Re: Nashoba Satellite Emergency Facility  
490 Main Street, Groton MA

On behalf of UMass Memorial Health Care, (the "Applicant"), VHB is pleased to provide the following responses to the transportation peer review letter prepared by Nitsch Engineering, dated July 15, 2025, regarding the proposed Nashoba Satellite Emergency Facility in Groton, MA (the "Project").

63 Gratuity Road Project Generated Trips  
PM Peak Hour

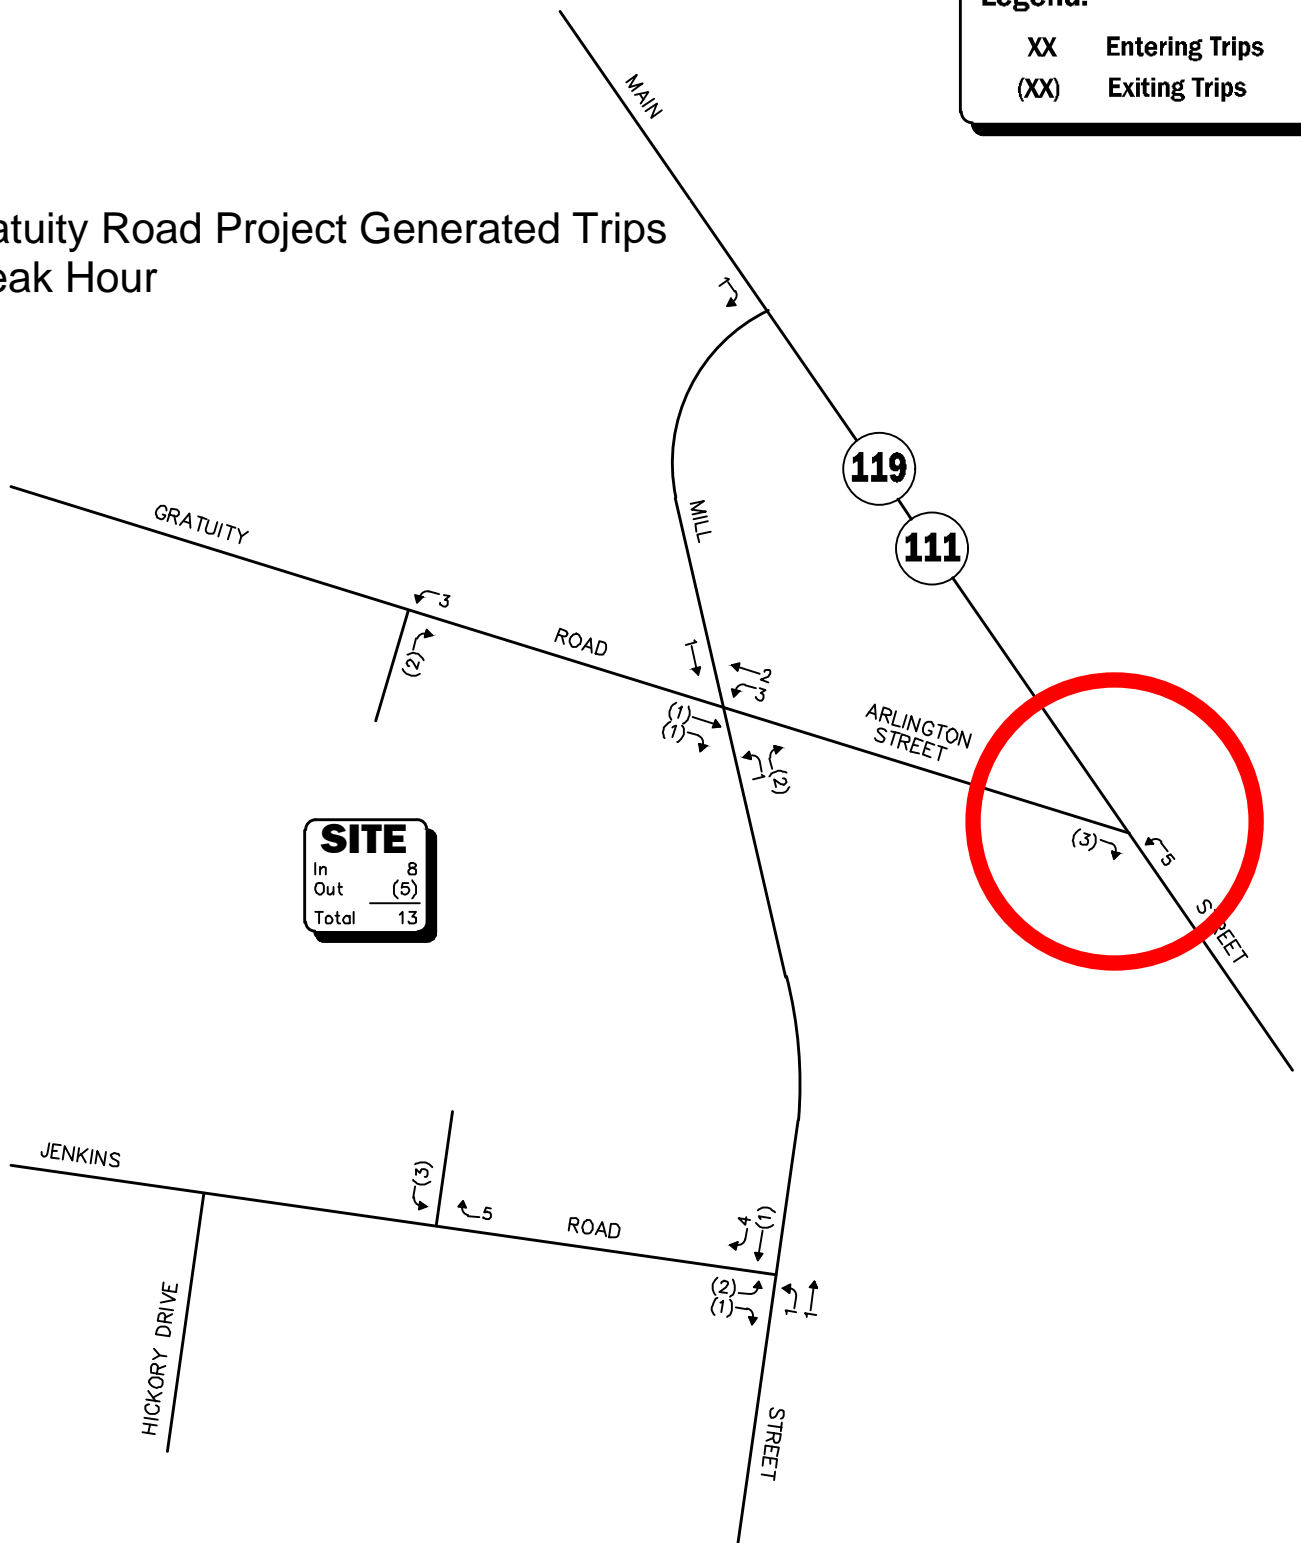
Comment 12. *"In Figures 4 and 5, the left and right turn volumes at the intersection of Main Street and Arlington Street indicate no increase in volumes between Existing and No-Build conditions. Nitsch confirms from the Application for the residential development at 63 Gratuity Road that such development would generate additional trips at this intersection of seven vehicles in the AM peak hour and 10 vehicles in the PM peak hour at these two locations. Nitsch notes that 63 Gratuity Road was identified as a Site-Specific Growth project on page 22 along with two additional projects: 500 Main Street, and Village at Shepley Hill. Nitsch recommends the Applicant clarify if Site-Specific volumes were added between Existing and No-Build conditions for the three (3) Site-Specific projects identified on page 22, and if additional site-specific traffic volumes should be added within the study area."*

Response: Based on information presented in the traffic study prepared for the residential development at 63 Gratuity Road, that project will generate a total of 5 trips through the intersection of Main Street at Arlington Street during the weekday morning peak hour and 8 trips during the weekday evening peak hour. The worksheets from the TIA prepared for the proposed 63 Gratuity Road residential development are provided in the attachment to this response letter.

Updated traffic volume networks and operations analysis that add the trips related to 63 Gratuity Road are provided in the attachment to this response letter. The additional 5 trips during the weekday morning peak hour and 8 trips during the weekday evening peak hour generated by the 63 Gratuity Road project will not materially change the operational analysis results at the intersection that were presented in the TIA under the 2032 No-Build and 2032 Build conditions. The revised intersection operations analysis for the intersection of Main Street at Arlington Street is shown in Table 1.
